**ZONING ADMINISTRATOR STAFF REPORT**  
Meeting Date: May 1, 2024

RE: Truckee Overhead Door Zoning Clearance and Minor Use Permit (Planning Application No. 2023-00000116/ZC-MUP-SP; 13418 Donner Pass Road; APN 018-363-012); Applicant/Owner: Scott Kessler, Truckee Overhead Door; Agent: Gavin Ball

Figure 4: Site Plan

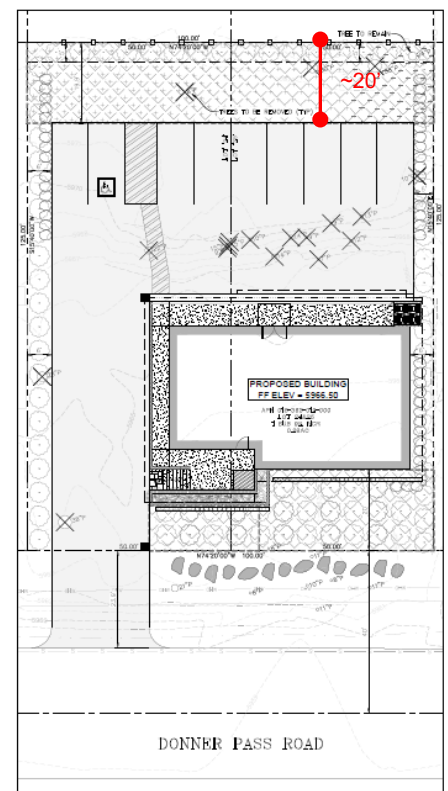
For the proposed project, one parking space is required for the residential unit. Since the Mixed-Use Development section does not specifically waive the requirement for the fully enclosed garage space requirement, the one residential parking space is required to be located a fully enclosed garage. For the commercial use, 7.9 parking spaces are required ( $1,975 \text{ s.f.} / 250 \text{ s.f.} = 7.9$  parking spaces based on one space per 250 s.f. of gross floor area for the first 5,000 s.f. for an office).

The applicant is currently proposing one residential parking space, as required by Section 18.58.140 (Mixed-Use Development), but is not proposing that the space be in a fully enclosed garage. The applicant is requesting a waiver of the fully enclosed garage requirement as described in detail below.

Staff believes that the Development Code is clear that while the parking requirements for the residential unit has been reduced to one, the one space is required to be in a fully enclosed garage. Without a Planned Development request to waive a development standard, staff does not believe that the requirement for a fully enclosed garage can be waived. Staff recommends Condition of Approval No. 26 requiring a fully enclosed parking space for the residential unit or recordation of an affordable housing deed restriction on the residential unit. If a fully enclosed garage is required by the Zoning Administrator, staff recommends allowing the applicant to work with staff on design and location, with ultimate approval by the Community Development Director. However, the Zoning Administrator may wish to consider if the design of the garage should return to the Zoning Administrator for review and approval or if specific parameters for design should be included in the condition of approval. At the minimum, the required setback for the garage structure is required to be equal to the height of the building or 15 feet, whichever is greater. As currently proposed, the rear of the parking lot is approximately 20 feet away from the rear property line. See Figure 4 for the site plan.

As noted previously, staff believes that the requirements of the Development Code are clear and only the quantity of parking spaces has been reduced through Section 18.58.140 (Mixed-Use Development) as an incentive; the type of parking required, with a minimum of one parking space in a fully enclosed garage has not been waived or removed. The justification provided by the applicant would be appropriate in a larger policy discussion when changes to the Development Code are being considered. Further, staff notes that previously, the Planning Commission has reviewed mixed-use projects in the Manufacturing zoning district where the fully enclosed garage requirement was waived as part of a Planned Development.

Figure 5: Zoning

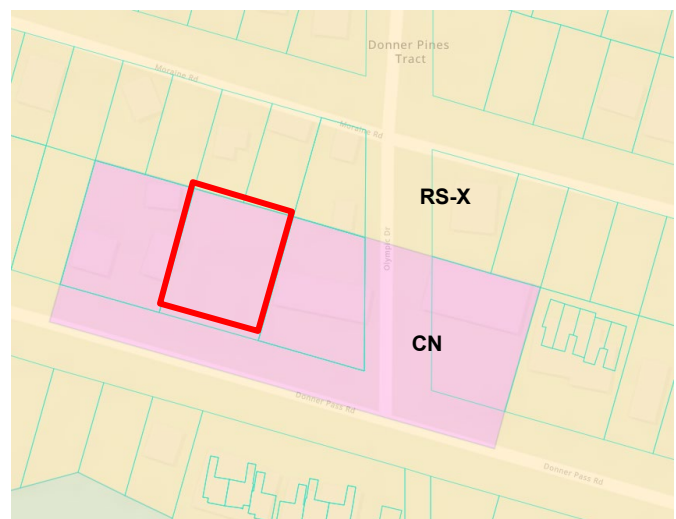
The project site and the two adjacent parcels to the east and west are located in the CN zoning district. The parcel to the rear of the project site is located in RS-X (Single-family residential, no further dwelling units) zoning district. In order to comply with the Screening and Buffer requirements of the Development Code, the applicant is proposing a 30.5-foot-tall building setback approximately 64 feet from the rear property line that abuts the residential zoning district to the rear. A six-foot tall dog-ear cedar wood fence with planks on both sides of the rails is proposed along the rear property line within the five-foot public utility easement with landscaping proposed on the interior. The applicant is proposing a mixture of 12 shrubs, including Lemmon's willows and Redtwig Dogwood, and two Scouler's willows along the 100-foot rear property line. In order to be in compliance with the requirements for screening, five trees, and 10 shrubs are required. Staff recommends Condition of Approval No. 30 requiring modifications to the landscaping plan to ensure

compliance with this requirement, including incorporation of at least five trees, with at least four trees sized at #15.
